Roe Highway Extension

Response to Public Submissions

31 May 2013

60100953-413D-EN-REP-0007

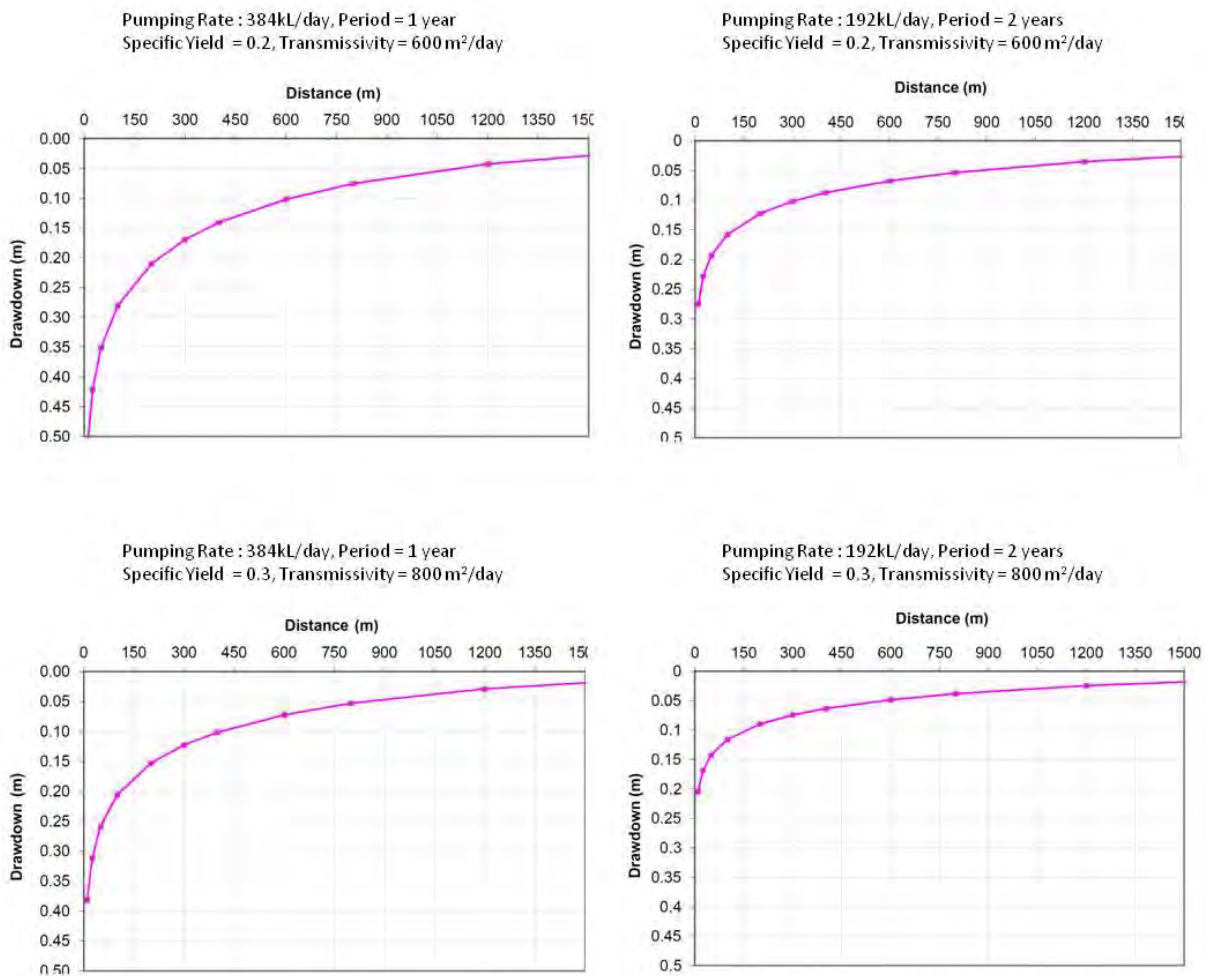
An assessment of the drawdown impacts from groundwater abstraction has been conducted since the publication of the PER. This information is presented in more detail in the Water Management Strategy (Appendix E), but is summarised below.

Then the maximum drawdown at the abstraction point will be 0.5m (Figure 2). DoW's Table 1 has as a "low impact drawdown" as 0.25m for wetland vegetation. Provided any bores for groundwater abstraction are located at least 150m from any wetland, then the impact of drawdown will be in the "low" impact category.

On the basis of advice from the Department of Water, abstraction will not occur within 1.5km of Bibra Lake or North Lake. Any abstraction bores located near Groundwater Dependent Ecosystems will also be at a sufficient distance so any potential impacts are in the low category (less than 0.25m of drawdown). Prior to any abstraction, the Department of Water's Peel Regional Hydrogeologist will be consulted on the location of abstraction bores and what baseline groundwater monitoring may be required to inform the groundwater abstraction licence.

Figure 10: Potential Black Cockatoo Foraging Habitat within 15km radius of Project Area. Sources: DEC's dataset 'CBC areas requiring further investigation' and Appendix M of the PER.

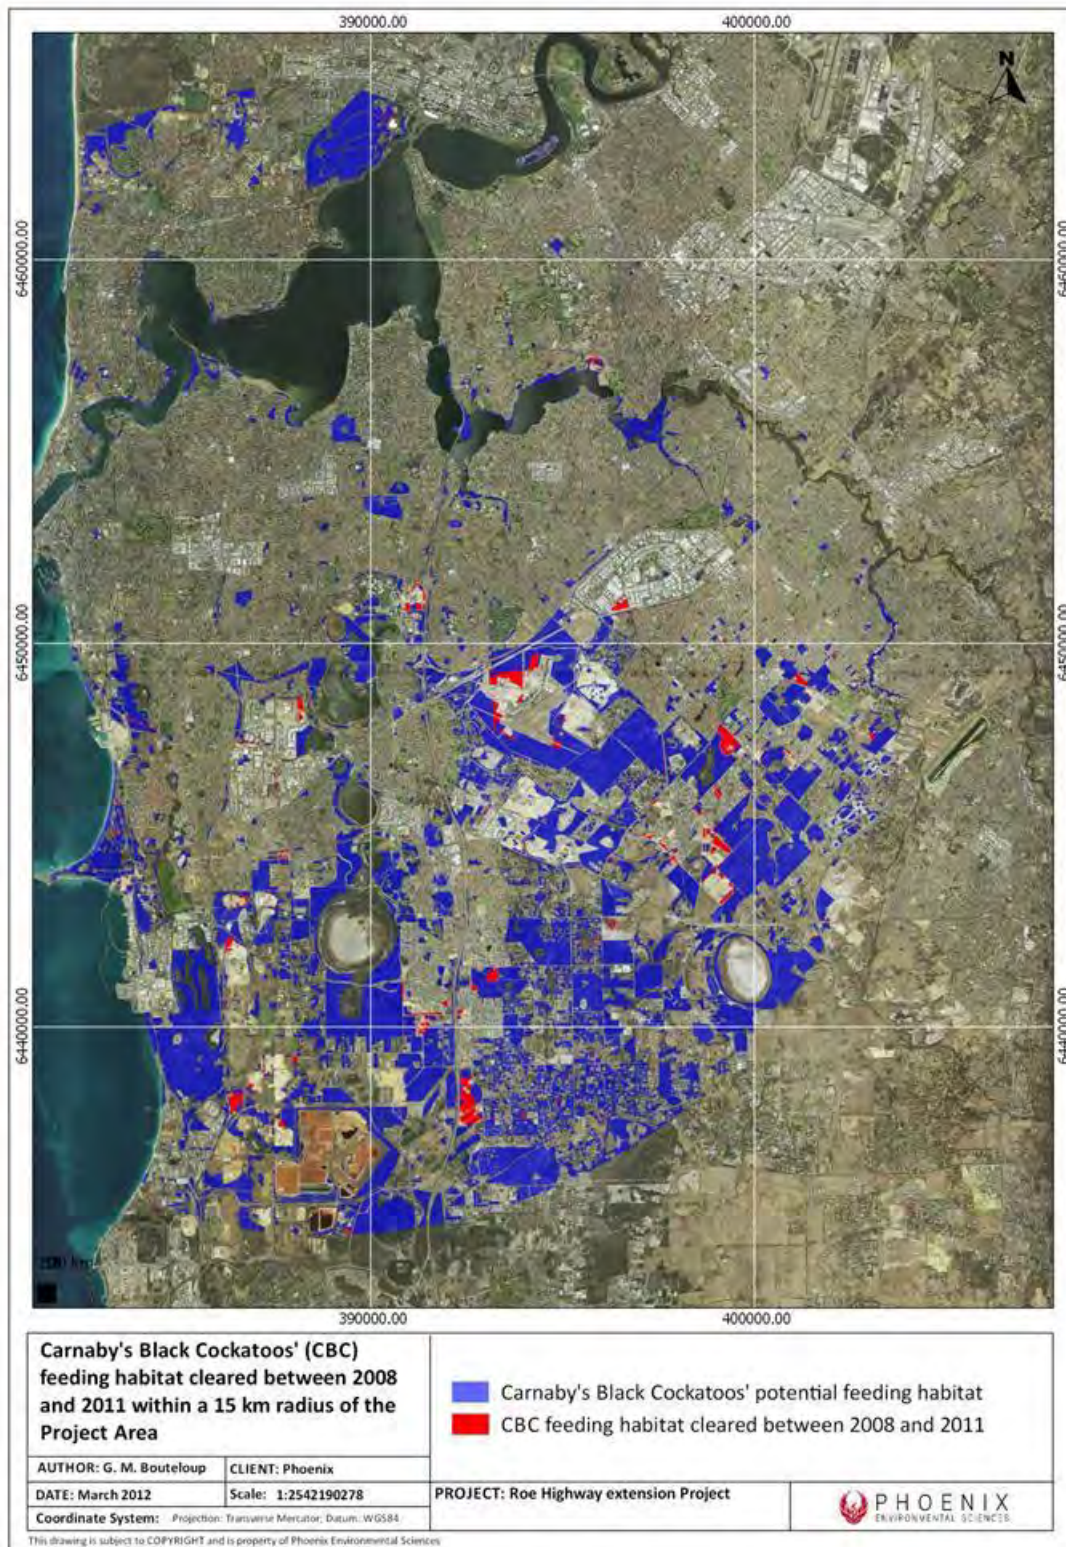
Submission 7.3-5: Text in table 6.7-3 (and table 8.1-2, page 642) claims there to be 9,133 ha of cockatoo feeding habitat within a 15 km radius. This information is not substantiated in the PER or appendices. There are no maps and no description of how this was calculated and it is therefore unknown what proportion of this area is wetland vegetation and other non-foraging habitat. A reference and/or map is required to demonstrate the claim (page 500) that 9,133 ha of cockatoo feeding habitat is found within a 15 km radius of the project site, in order to confirm this statement against DEC data.

The estimate of potential foraging habitat for black cockatoos within the 15km radius of the project area was derived from the DEC dataset of potential foraging habitat for Carnaby's Cockatoo 'CBC areas requiring further investigation'. No such dataset exists for Forest Red-tailed Black Cockatoo and therefore the Carnaby's dataset was used as a proxy. Figure 10 shows the extent of potential black cockatoo foraging habitat within the 15km radius.
